TED Bernhardt Textile Industry Ltd.

7 September 2023

Observations

**Design report to be revised for in-situ
material strength**

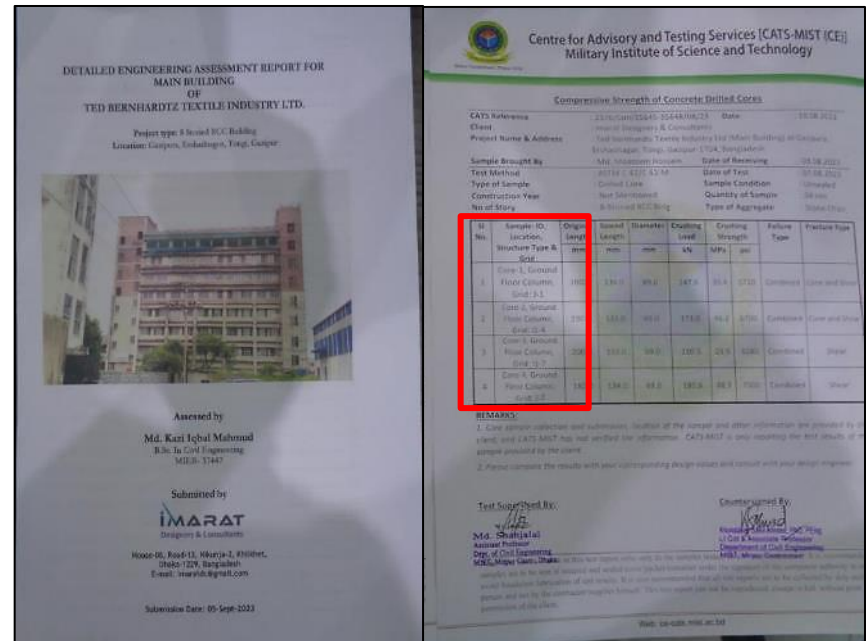
The 8 storied building was constructed in two phases. 1st phase construction period was February 2014 to March 2018 and completed till 5 storied. 2nd phase construction period was March 2020 to October 2021 and completed rest of three storied.

The factory of safety of allowable pile capacity was not clearly mentioned in the DEA report which to be incorporated.

The building engineer is required to revise the DEA as per in-situ material strength.

End connection of steel box

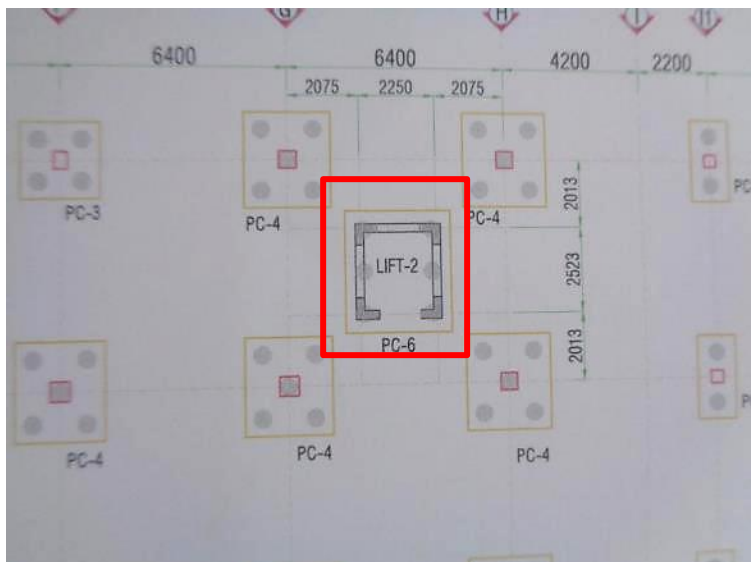
Cable tray and several utility service pipes are supported on steel box beam.

Adequacy of steel box member and its end connection did not include in the DEA report. The building engineer is required to incorporate the steel member & connection adequacy check in the DEA report.

Discrepancies in as-built drawings

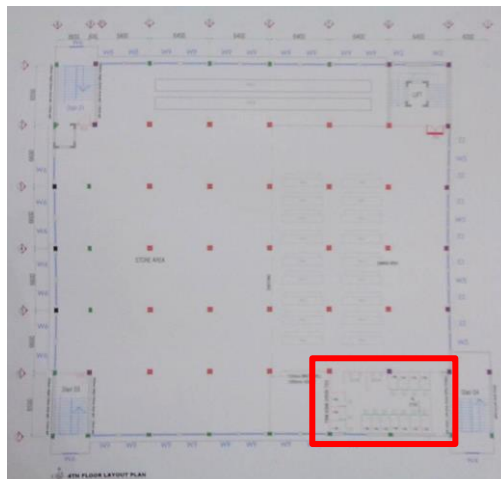
Drawing: L-shape column in lift core

Onsite: Shear wall in lift core

As-built drawings doesn't match with as-built condition. The building engineer is required to survey the structures and prepare accurate as-built drawings.

Exposed rebar on roof

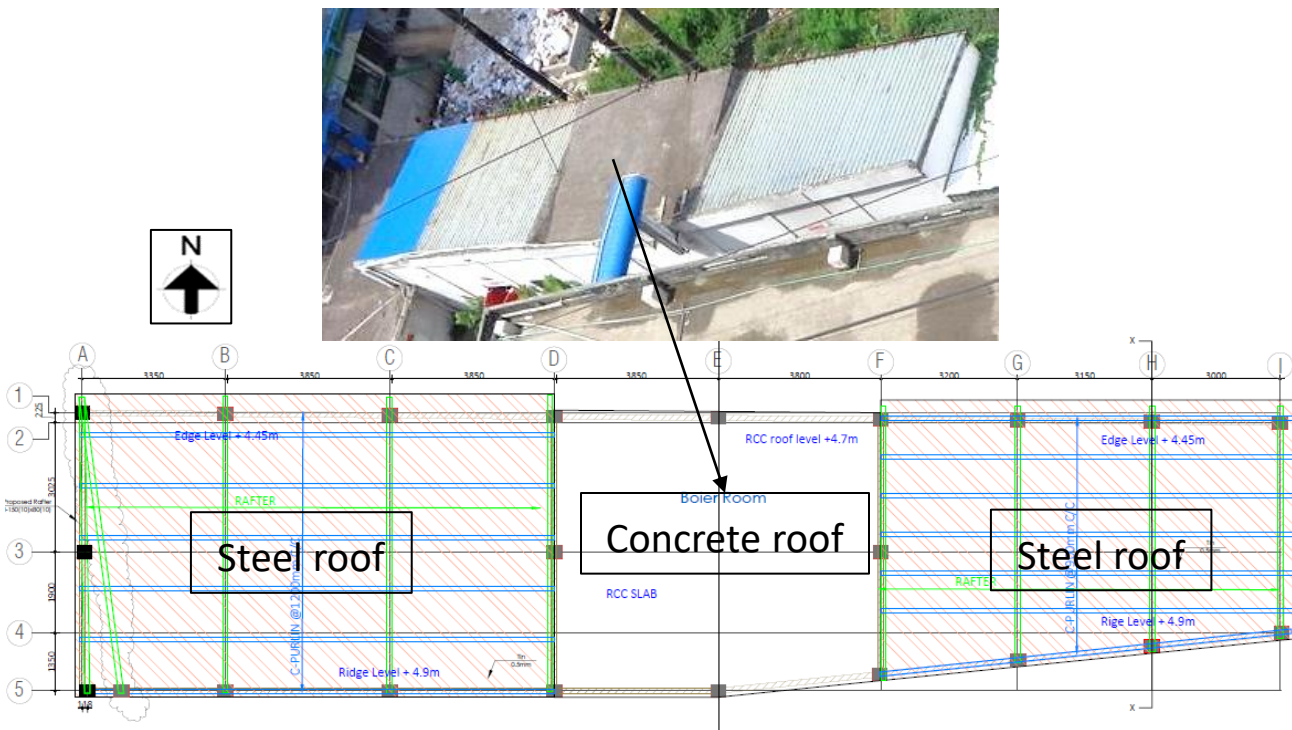
Exposed rebar observed on roof which is prone to corrosion. The factory is required to provide anti-corrosive coating on the exposed rebar or remove the rebars & seal the exposed areas.
